DEVELOPMENT APPLICATION ASSESSMENT REPORT

Application Number:	DA2024/0741
----------------------------	-------------

PROPOSED DEVELOPMENT IN DETAIL

Figure 1 - approved site plan for DA2023/1617 at 32A Nareen Parade

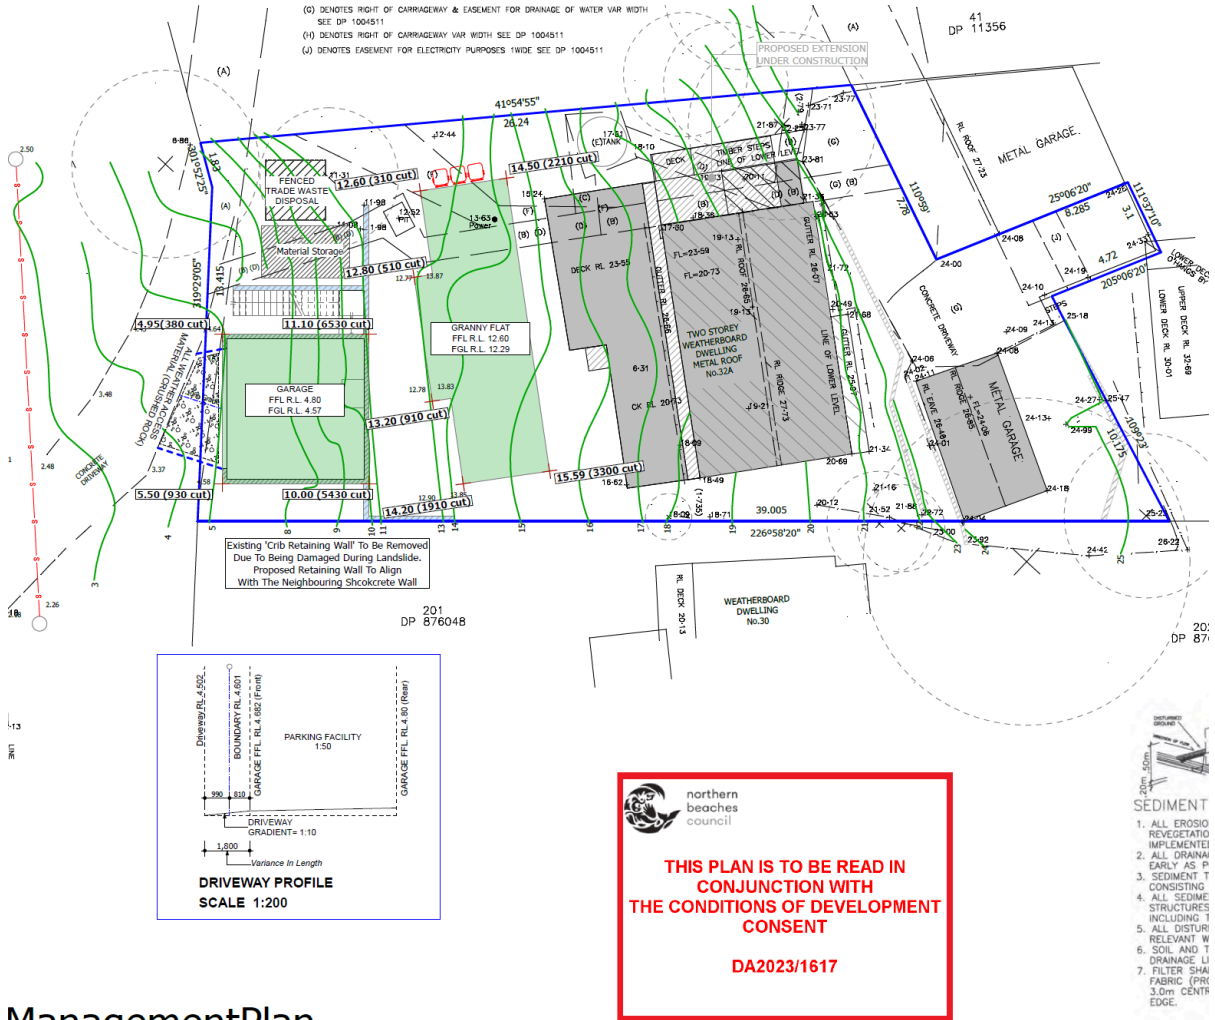
In response, a review of the approved plans under Development Consent DA2023/1617 and the proposed civil plans has concluded that the driveway will not conflict with the footprint of the approved garage (which is yet to be constructed) at 32A Nareen Parade (see **Figure 1**).

Notwithstanding, a condition is recommended that requires the civil plans to be updated to include the approved garage on 32A Nareen Parade, so as to ensure that any conflicts are avoided. This information must be submitted to the Certifier for approval prior to the issue of the construction certificate.
